# SERVICE INFORMATION

## STANDARD AND TRIUMPH VEHICLES (NOT FOR PUBLICATION)

**No.** EIGHT/2/M SUPPRESSION OF RADIO AND TELEVISION **Date** JANUARY 1954  
(AND OTHER MODELS) INTERFERENCE

1 ILLUSTRATION.

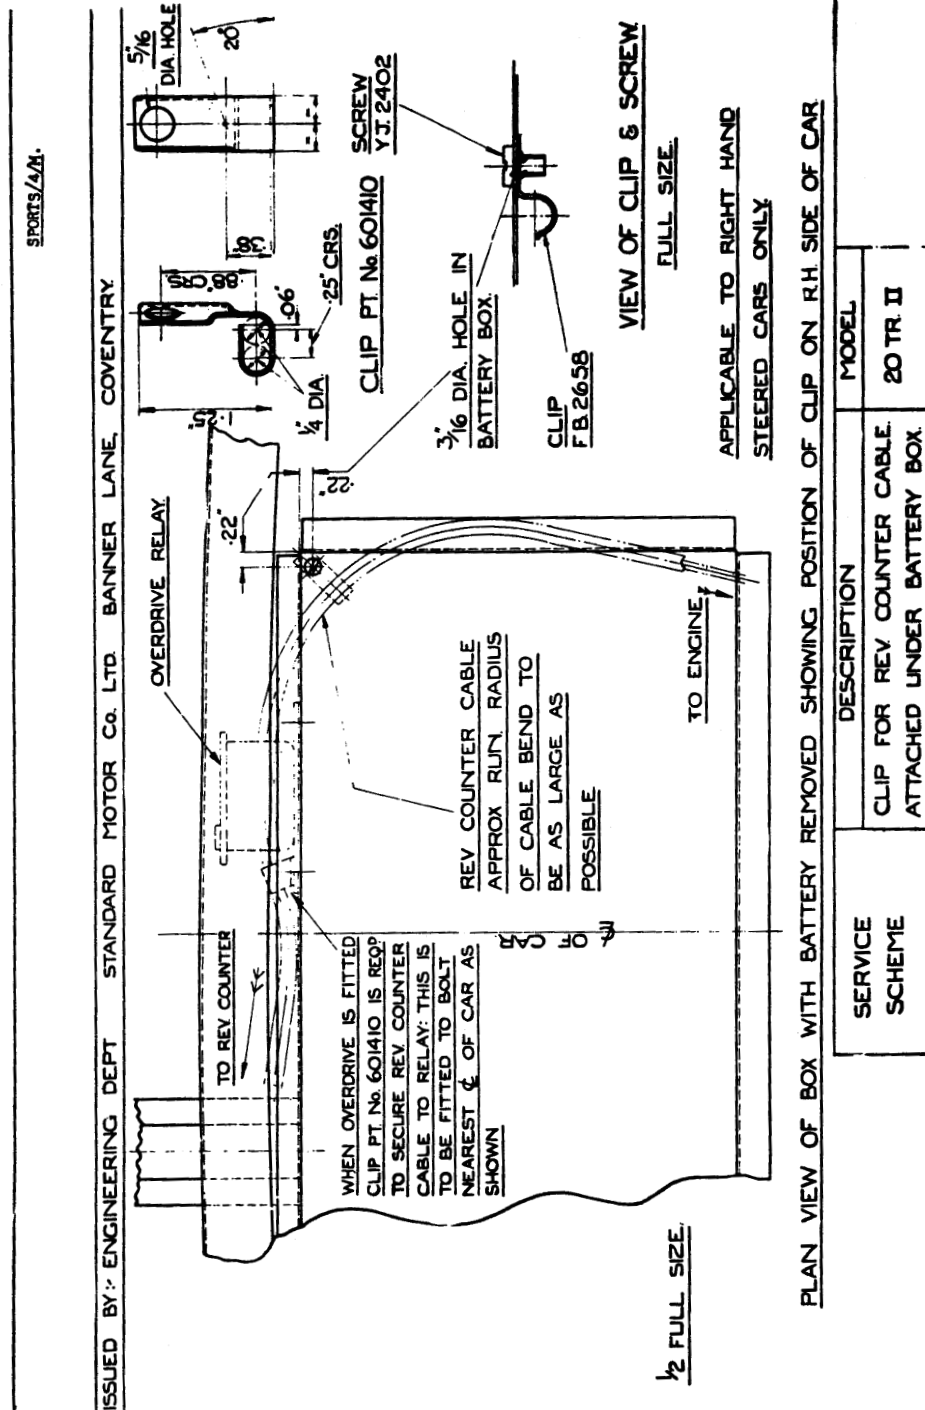
A new Rev. Counter Cable Securing Clip, Part No. 601410, is now fitted, and located on one of the relay securing screws and positioned so as to prevent electrical contact with the relay. The correct positioning of this clip is shown in the illustration.

1 ILLUSTRATION.

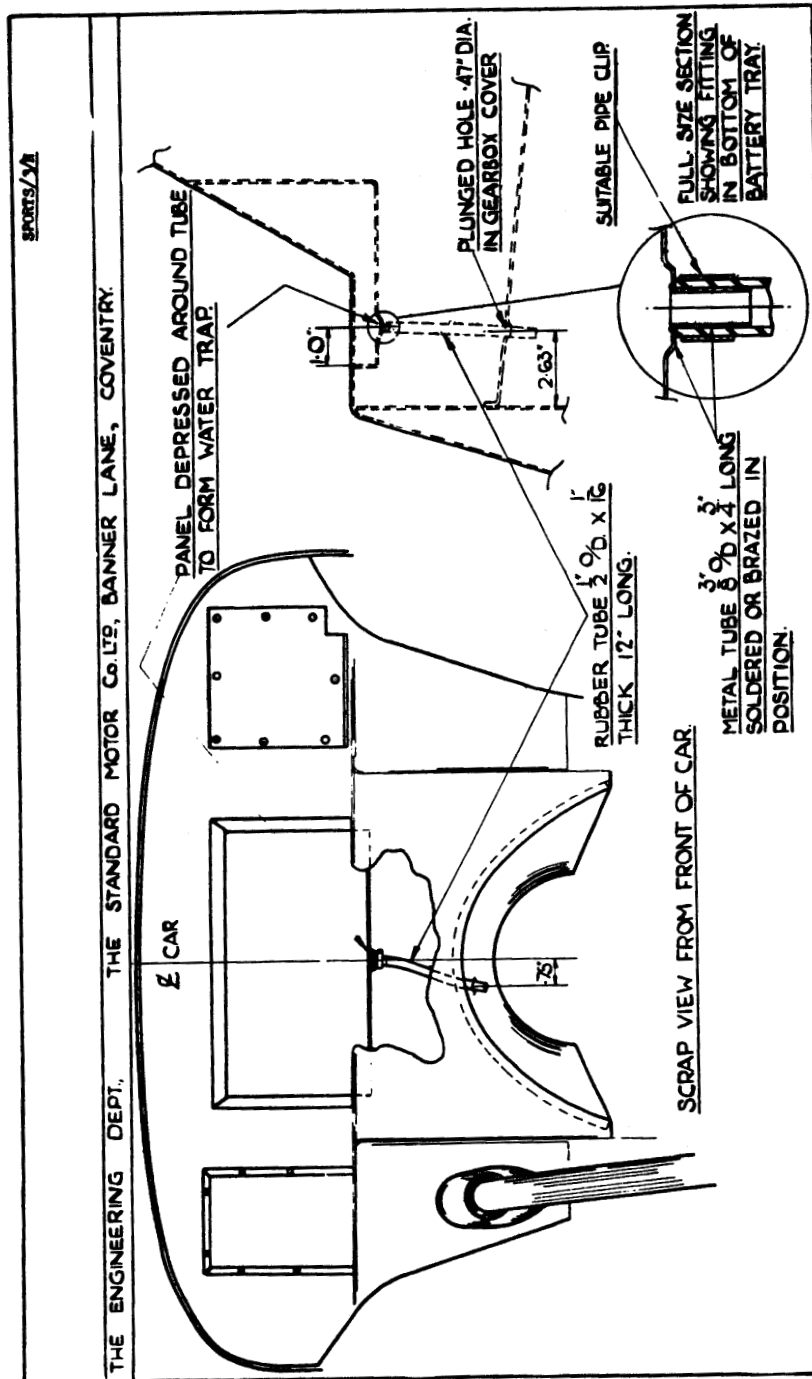
A battery box drain tube has now been incorporated in normal manufacture and was introduced at Commission No. TS. 3288. Retrospective action can be taken with earlier cars, if desired, as shown in the illustration.

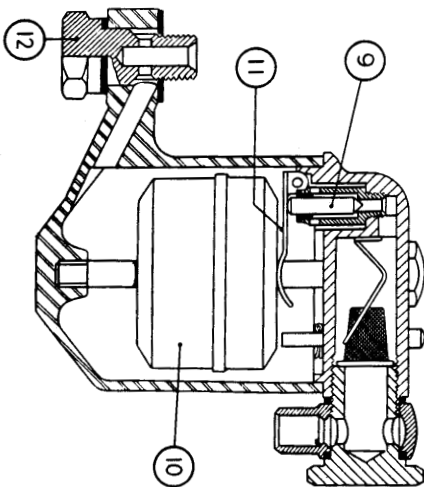
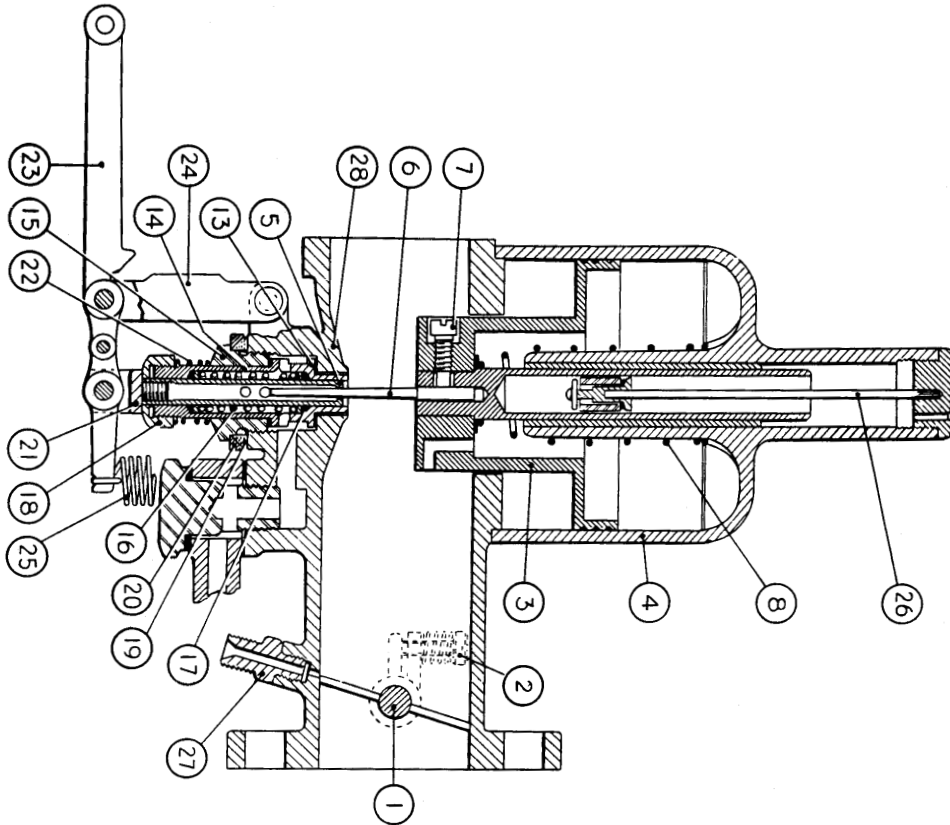
The shoulder of the needle should be flush with the seat of the needle jet. The correct datum point for each is shown.

1 ILLUSTRATION.

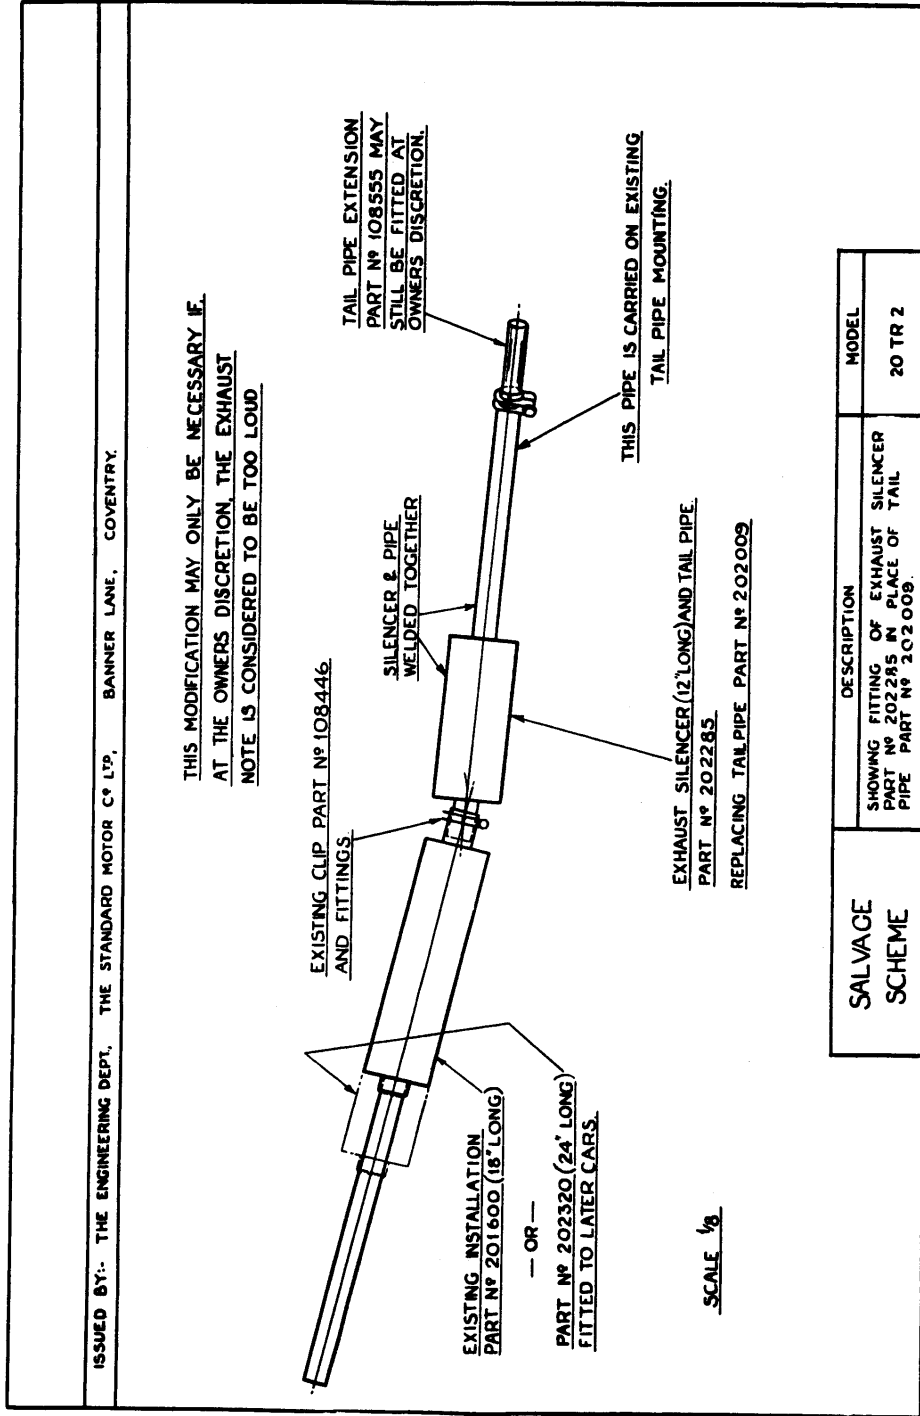
A 12" silencer with an integral tail pipe, as is shown in the illustration, has now been made available under Part No. 202285 to give the greater silencing desired by particular customers. The tail pipe extension, Part No. 108555, is completely interchangeable with either length of main silencer and may be fitted retrospectively if required.
